DEPARTMENT OF PLANNING AND COMMUNITY DEVELOPMENT
DESIGN RESPONSE CONFERENCE

File No.: DRC09-00003
Project Name: Hector's Expansion
Applicant: Rick Chesmore, Chesmore/Buck Architecture
Project Planner: Jon Regala, Senior Planner
Date: October 5, 2009
Meeting Date and Place: 7:00 pm, Monday, October 5, 2009
City Hall Council Chambers
123 5th Avenue, Kirkland

DEVELOPMENT STANDARDS
CASE NO.: DRC09-00003
PCD FILE NO.:DRC09-00003

SITE PLAN

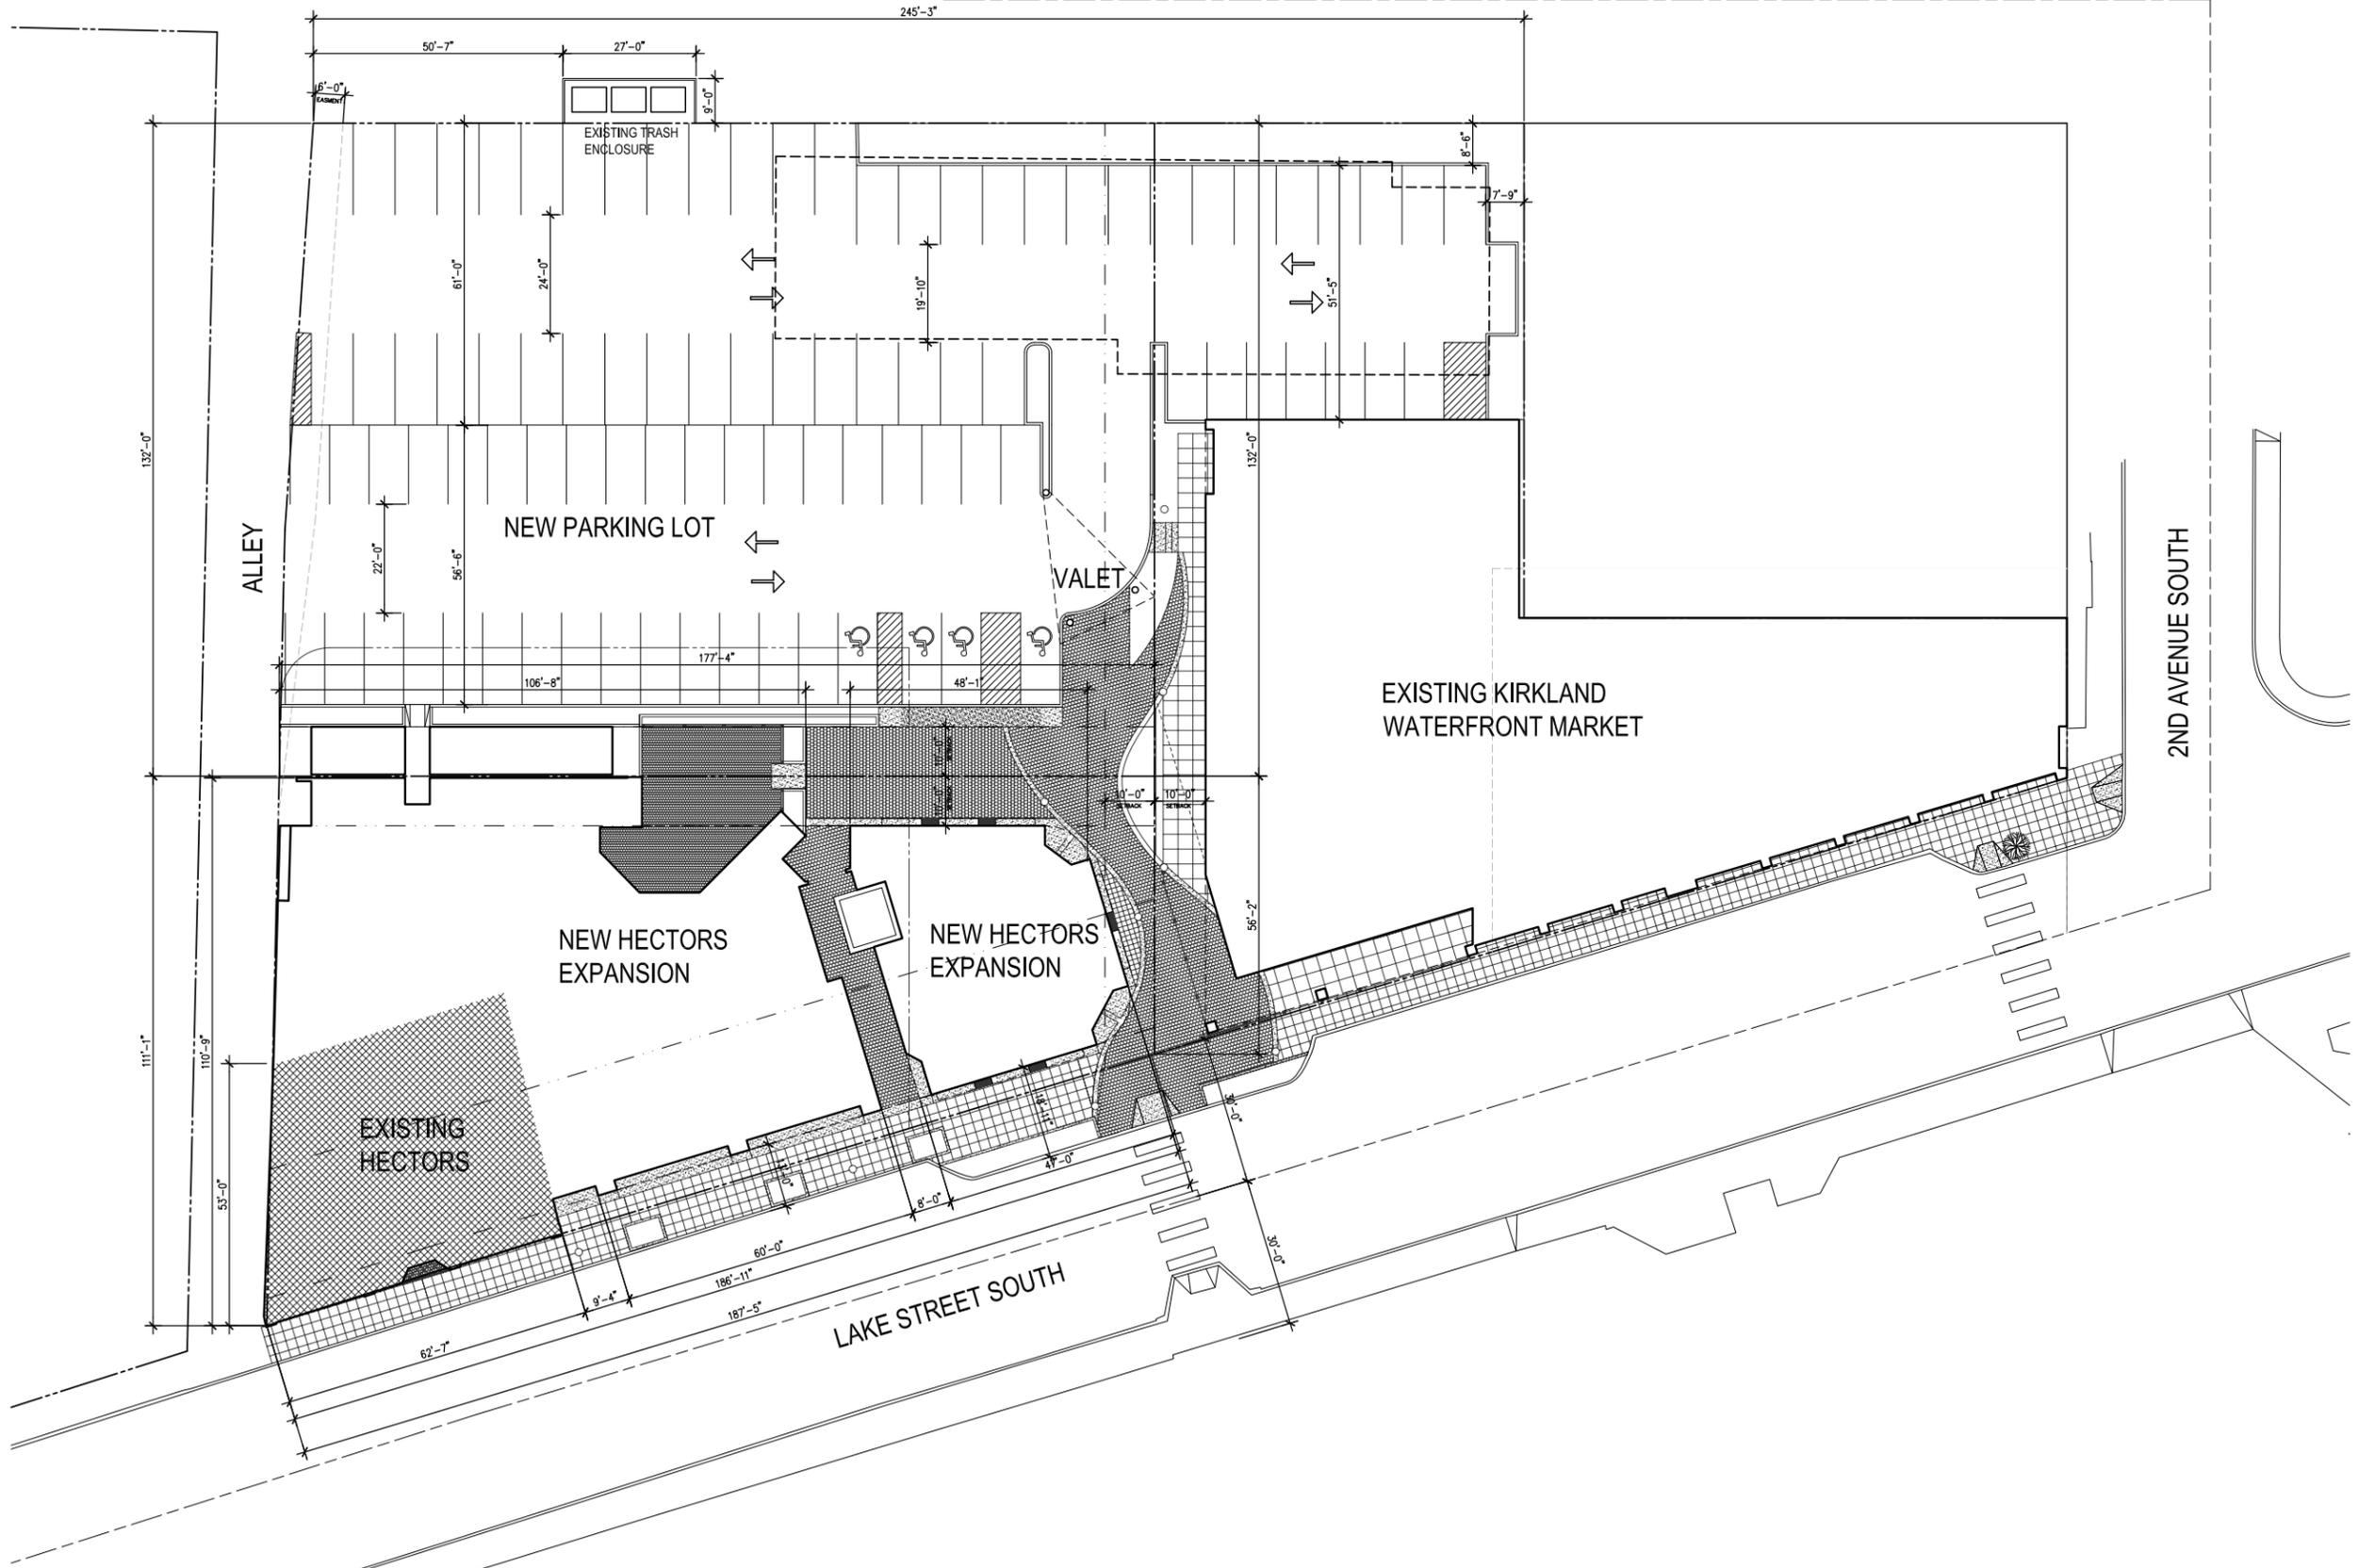
3. Parking Information.
 - The required parking calculations are noted the site plan sheet 1.1.
 - The parking lot east of the proposed project will be modified as shown on the site plan sheet 1.1. Currently the parking lot consists of parking for 69 vehicles. We will be modifying the lot to achieve parking for 88 parking stalls including 4 stalls for the disabled. We will discuss the parking ratios at our next presentation.

2.0

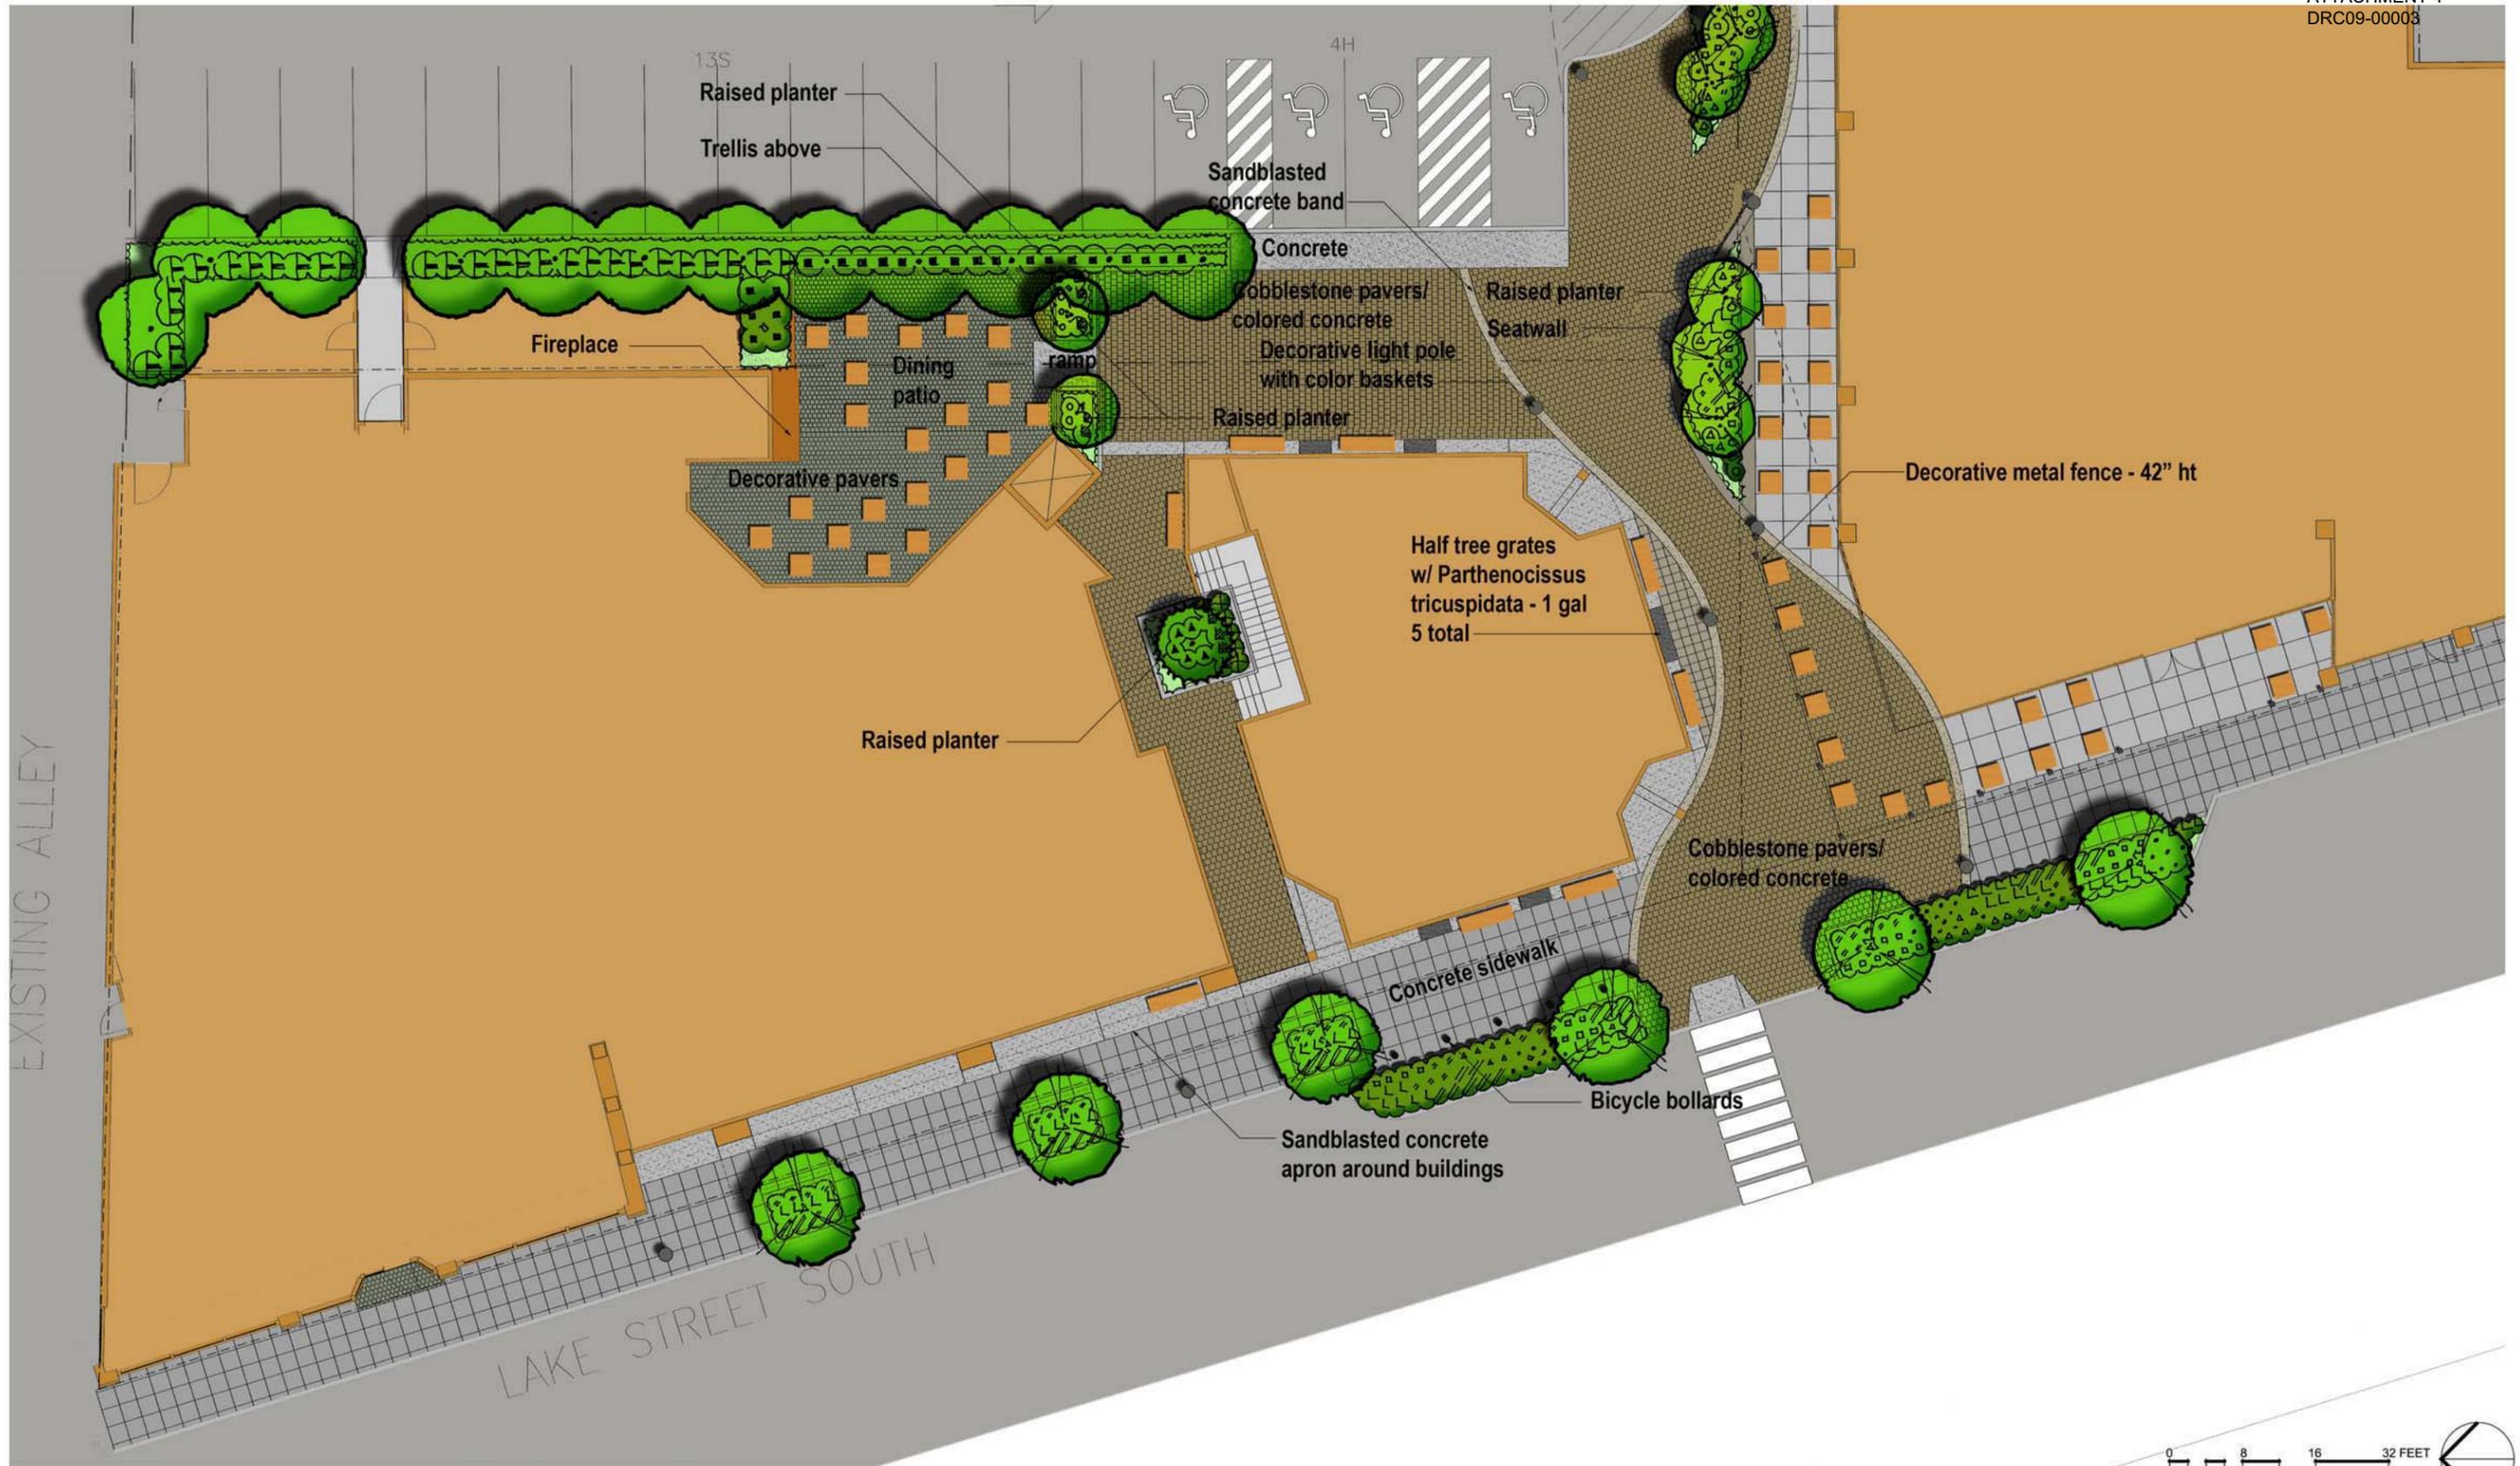
- Please review sheet 2.0 the overall landscape plan.
15. Site Plan should be expanded to include surrounding buildings and showing pedestrian access.
 - Please review the vicinity map shown on sheet 1.0 and the site plan drawing sheet 1.1.

16. Landscape Plan- Include roof and street frontage.
 - Please review Landscape plan sheets 2.0, 2.1, 2.2, and 2.3.
17. Lighting Plan- Roof and Street.
 - Please review overall landscape plan sheet 2.0 and Roof level landscape plan sheet 2.3.

EAST EXTERIOR ELEVATION
1/8" = 1'-0"

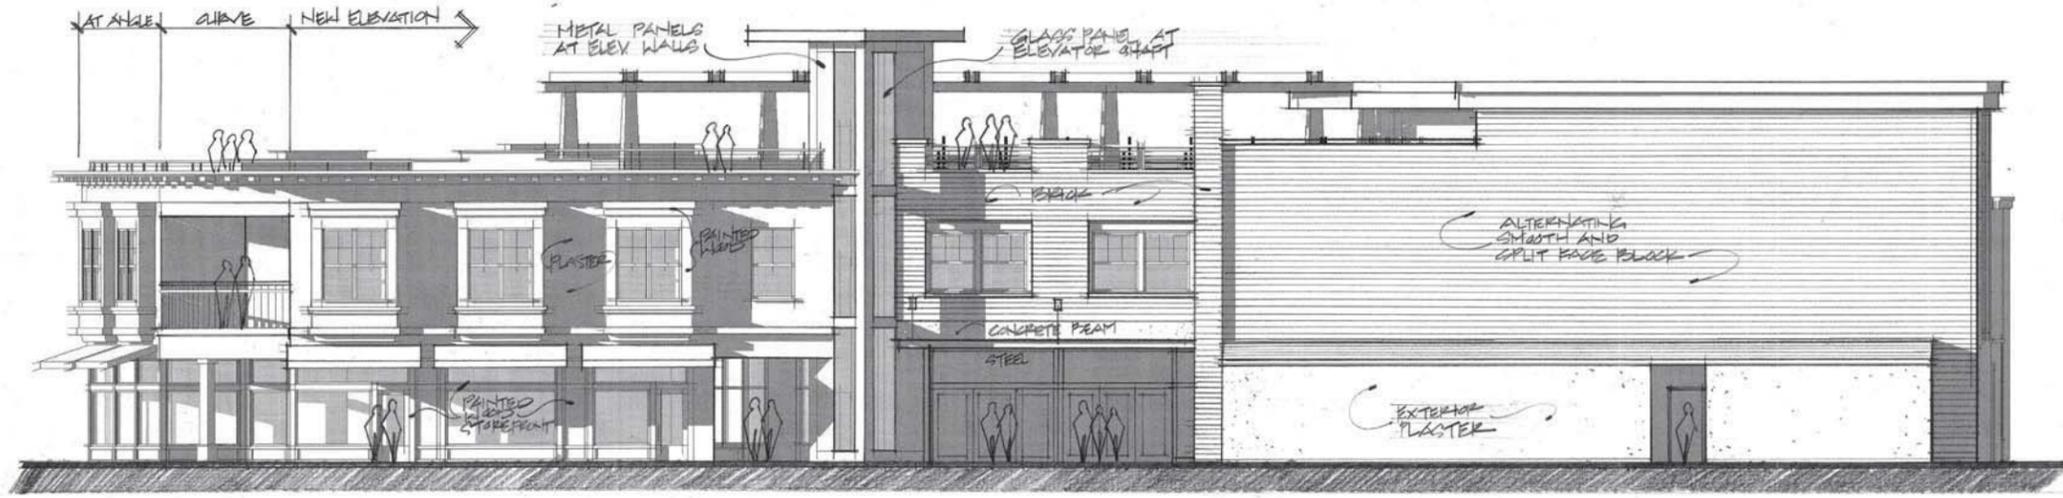
4. Design/Massing of the third story.
 - Please review the Roof Floor Plan sheet 3.2.
 - Also, review the north and east elevations and massing studies shown on sheets 4.0, 4.1, 4.2, and 4.3.
